July 6, 2006  
L-06-114

Subject: Beaver Valley Power Station, Unit Nos. 1 and 2  
BV-1 Docket No. 50-334, License No. DPR-66  
BV-2 Docket No. 50-412, License No. NPF-73  
Additional Information in Support of License Amendment Request Nos. 302  
and 173 (Unit No. 1 TAC No. MC4645/Unit No. 2 TAC No. MC4646)

### Additional Information: Long Term Core Cooling Transients for Proposed EPU Conditions (BVPS-1 & 2)

Figure-1 BVPS-2 1.5-Inch Break, RCS Pressure/Temperature Response, ARVs Only

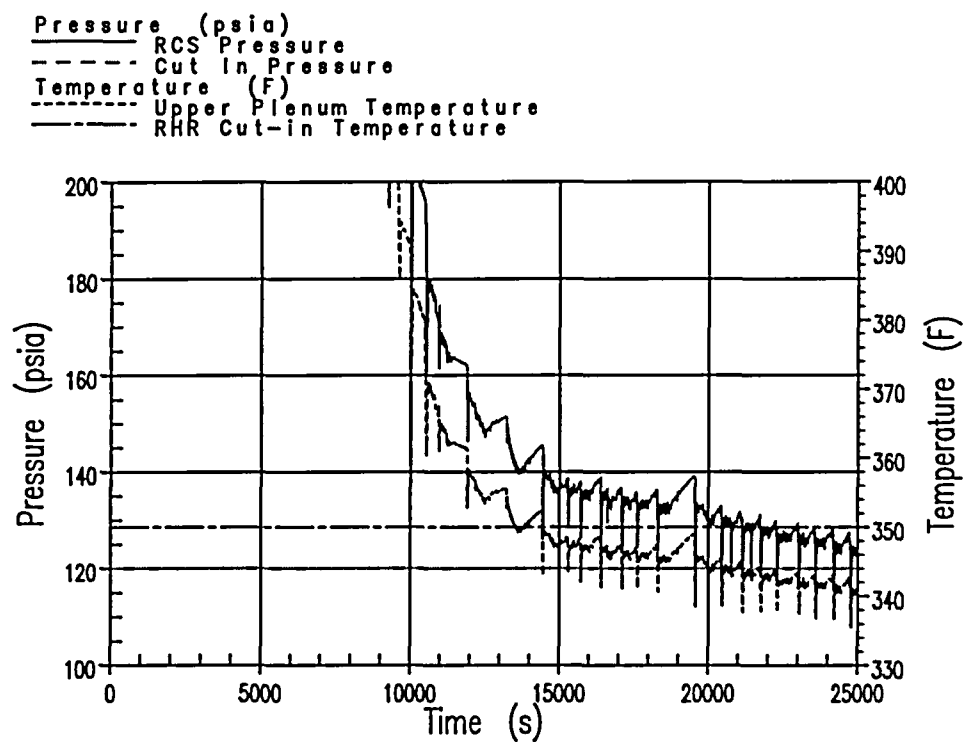
NRC review of the EPU LAR indicated that additional analysis relative to post-LOCA long term core cooling transients under the proposed EPU conditions was necessary.

The 1.5-inch cold leg break RCS cooldown and depressurization results are presented in Figure-1 and Figure-2. Figure-1 demonstrates the system response to the 1.5-inch cold leg break assuming that only the steam generator ARVs are utilized to perform the cooldown and depressurization function. As can be seen, the RCS temperature condition was achieved at approximately 14,000 seconds (3.89 hours) into the transient or 2.89 hours following the initiation of the RCS cooldown and depressurization. At 6 hours (5 hours after initiation of cooldown) the RCS had only depressurized to approximately 130 psia; therefore, in order to demonstrate acceptable depressurization to the desired RCS pressure of 120 psia, opening of the Pressurizer Power Operated Relief Valves (PORVs) is required. Figure-2 presents the same information assuming that three Pressurizer PORVs opened at 18,100 seconds (5.03 hours) to demonstrate that RCS depressurization can be achieved. As can be seen, RCS pressure can be reduced to below 120 psia approximately 600 seconds (10 minutes) after opening all three Pressurizer PORVs. The choice of 18,100 seconds to accelerate RCS depressurization using the PORVs was rather arbitrary and could have been commenced much earlier. It should be noted that even with the SG ARVs discharging and all three Pressurizer PORVs open, the RCS pressure stabilizes at approximately 110 psia under this analysis scenario. This is because the operable SG ADVs and PORVs are either under or close to critical flow conditions. If this were not the case, such as assuming either the BVPS-1 or BVPS-2 valve capacities with no failures, or assuming the availability of the condenser steam dump system, the RCS would be depressurized long before boric acid precipitation is a concern. Even under these circumstances, because of the high volume flow rates in the main steam system, RCS pressure will be slow to respond. This further reinforces the argument that no abrupt depressurization events can occur through either the ADVs or Pressurizer PORVs, thus RCS temperature remains high, promoting a very high boric acid solubility limit.
